Dane County, Wisconsin

Telecommunications Site Review New Support Structure

February 27, 2018

RE: Radio Frequency Engineering Review of CUP #2396 by AT&T Mobility / Martinson

Figure 3 – AT&T Current Coverage Map with CAF II Target Area

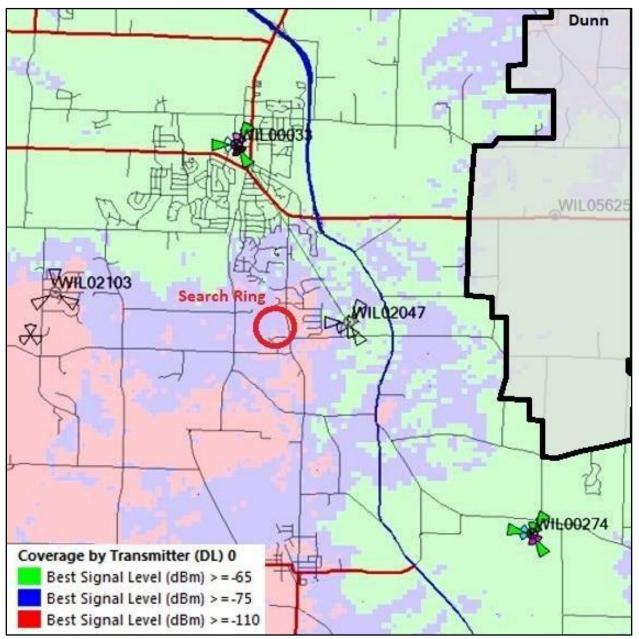
Figure 3 is a map with the current AT&T service (not considering the proposal), with an approximate overlay of the CAF II target areas. Most of the target area is well served based on the maps and only areas approaching Dunn would remain underserved. The Applicant should provide substantiation as to how this proposal at the proposed site will significantly improve CAF II broadband service to these areas in and around Dunn, a significant distance from the proposed site.

The Applicant has not commented on whether collocation on the existing SBA-owned tower located on State Highway 138 (shown in *Figure 3* as WIL05625) would meet the requirements and not require constructing this proposed new tower. The Applicant challenged this notion but erred in its report by referencing a different, shorter tower just east of the proposed site (not shown on map).

Figure 4 – AT&T Proposed Map with CAF II Target Area

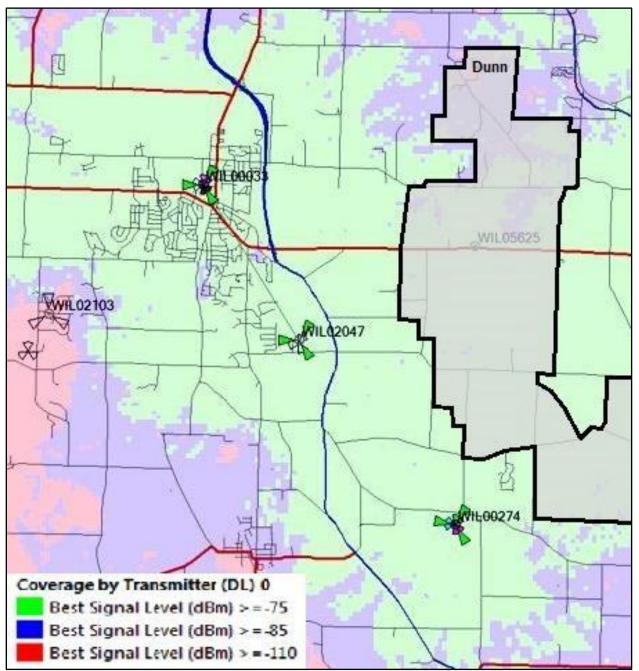
Figure 4 depicts the current AT&T service (with the proposal), and an approximate overlay of the CAF II target area. There is no recognizable improvement to areas near Dunn by the proposal when compared to Figure 3, due to the proposed site being too distant from Dunn. The alternate SBA site is shown on the map, about half the distance from Dunn and directly and within the CAF II target service area. The Applicant should evaluate this site to determine the feasibility of collocation on the existing tower for the WLL broadband service.

Figure 5 – AT&T Current Map Depicting Improvement Service Area (Dashed)

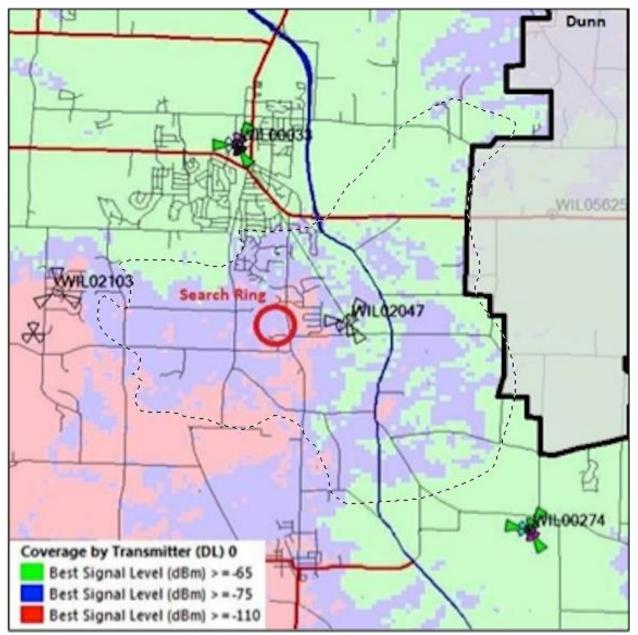
Figure 5 is a comparison between the maps in *Figure 3 & 4*. This comparison shows the existing coverage from *Figure 3* but has been cropped at the edges of the improved service. When compared to *Figure 3*, there are no significant areas of improvement within the CAF II target area (because all areas shown already have existing service) and the proposed service shown also does not approach the town of Dunn (which *figure 5* does not extend to due to lack of coverage).

Exhibit A – AT&T Coverage Map (Current)

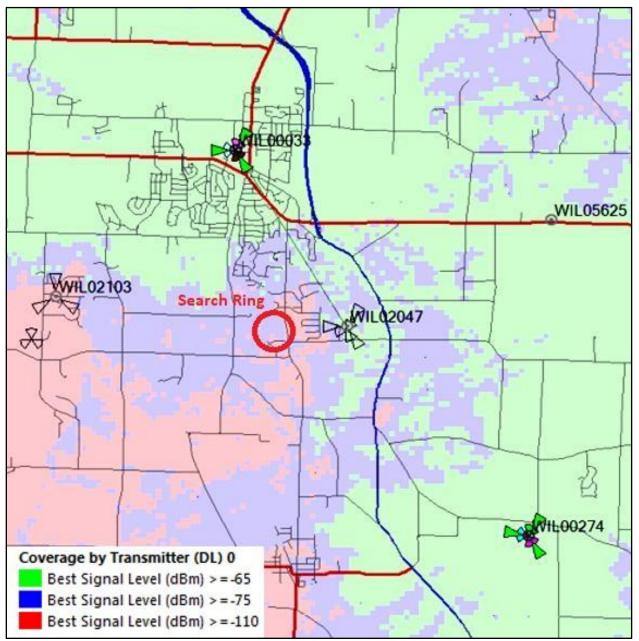
The legend indicates "indoor service" (the highest signal level for mobile service) is provided north and east of the proposed site, but only marginal service is available to the west (within the search ring) and continuing further to the southwest away from the search ring, *see Appendix, Exhibit A*. The green and blue areas (greater than -75 dBm) are considered indoor service for mobile cellular. The next two typical mobile categories of "in-vehicle" and "outdoor" are not shown, only what is considered marginal service in red (-105 dBm and lower). For CAF II service, the signal levels should be green. However, these specific CAF II target areas are not defined on this map. The proposed site is identified as "WIL02047" and the search ring is shown as a red circle.

Exhibit D – Second Search Ring Provided as Supplement

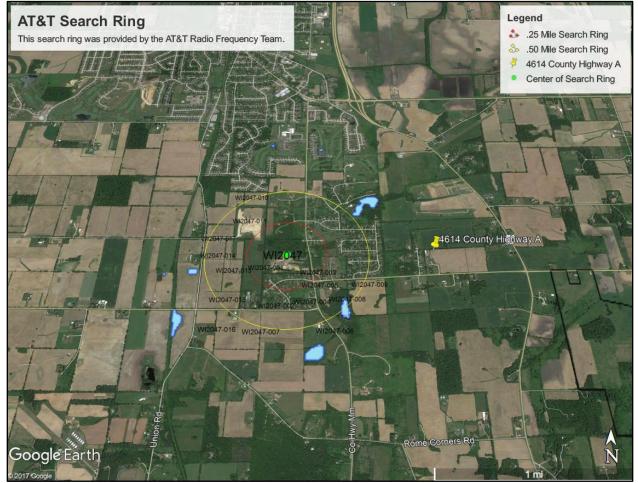
The Applicant also provided a new, expanded search ring, claiming no sites were available within the previous one, *see Appendix, Exhibit D.* Expanding the search ring is an acceptable practice when a site cannot be found, but this did not address the issue at hand, specifically, that the proposed tower remained to the east, still outside the new larger search ring. The Applicant did not demonstrate that all properties within either of the two search rings were pursued and eliminated as viable options.

In the October supplemental information, the Applicant discounted this search ring claiming it was too far west to achieve the required CAF II coverage goals. This is in direct conflict to the original application materials that "AT&T's engineers established a 0.5-mile search ring that
